To: Uglow Alistair
Subject: RE: Wright Construction - Highways
Switch-MessageId: d0781c365e2f4f8e9ad90e74663237ec

I've pasted Jon Pearson's rebuttals into this email, and my counter-responses to each one are shown in red. If you need any further assistance please contact me.

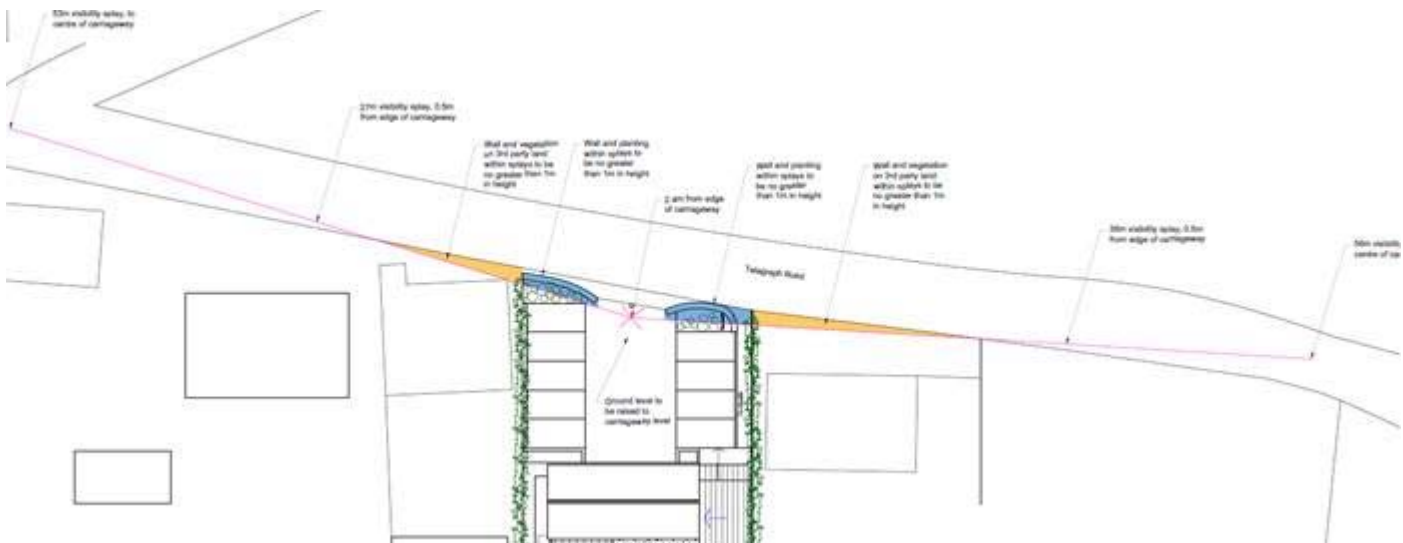
3.1.5 An additional concern with the potential difficulty in using the car park is that it could encourage customers instead to park on the road; or half on the road, half on the footway.

As stated above, there are no parking restrictions on the A3111, and vehicles do park. As to the assumption that some may wish to park on the footway, again this is an unqualified assumption and the photo in the TAN shows existing highway parking. As there is only an approximate total of 500 vehicles on the island (Census Data) and given the size of the business use, together with its sustainable location, the assumption of such large numbers of car borne customers is, again, unqualified.

If on-street parking already occurs, it is reasonable to predict that the aforementioned limitations of the car park and its access could cause an increase in such parking, with obvious detriment to the safe and free flow of traffic. No assumptions are being made; this is merely the description of a perfectly plausible scenario. Notwithstanding the number of vehicles on the island, it should be remembered that in only 2 hours on what is reportedly one of the quietest days of the year, 200 traffic movements were counted passing the application site. Traffic flows on the A3111 are by no means insignificant: the possibility that customers will prefer to park on the road than use a car park with restricted exiting visibility is one that should not be ignored.
